## **Product Change Notification**

#### PCN-IFC-7653-2022

Business Unit	Product Line Code	Type of Change	Action	Date of Issue
IFC - Industrial	BF2	Product Change	Notify Distributors and	3/4/2022
Field Connectivity		Notification	Field

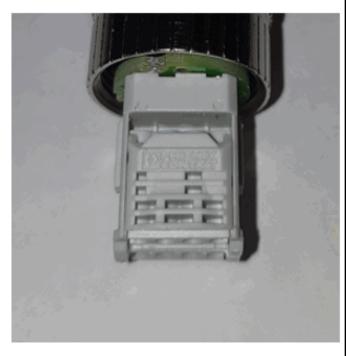
We have made changes to our shielded M12 IDC connectors. The M12 knurls and the knurled sleeves for fixing the sleeve housing will be changed from a brass turned part to die-cast zinc. As part of this change, the 4-pos. versions will no longer have a sticker marked NC on the connection block. The properties of the connectors remain unchanged and the existing approvals are still valid. Due to the current situation with the shortage of materials and disproportionate purchase quantities in 2021, we are having to bring forward this change that was originally planned for the future. Otherwise, we would be unable to maintain our supply capability.
